Date: October 2020

## **Dimension Tolerances Change of SLEC-B-EL: Clamping Screws with Eccentric Heads**

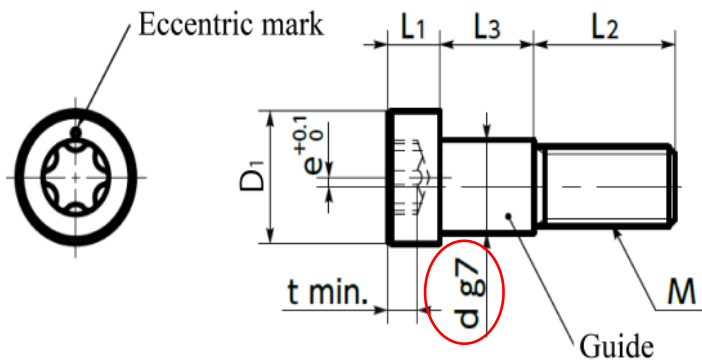
We hope you are doing well and appreciate your constant business support of NBK. The guide portion ("d" in the following dimension drawing) and mount fit tolerance for clamping screws with eccentric heads "SLEC-B-EL (guide type, electroless nickel plating)" listed in the [NBK Catalog 2017] will be changed as follows. We understand this change may bothersome but we appreciate your understanding.

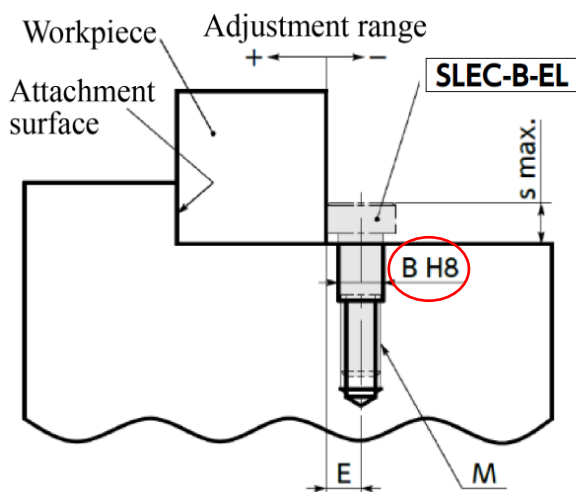
The fit tolerances between the guide and mount will be changed due to manufacturing reasons.

- Guide diameter (d) tolerance for SLEC-B-EL

Before Change	After Change
SLEC-M3-B-EL	g7	+0.008
SLEC-M4-B-EL		-0.016
SLEC-M5-B-EL		
SLEC-M6-B-EL		+0.007
SLEC-M8-B-EL		-0.020

- Mounting bore diameter (B) tolerance

Before Change	After Change
SLEC-B-EL All Sizes	H8	F8
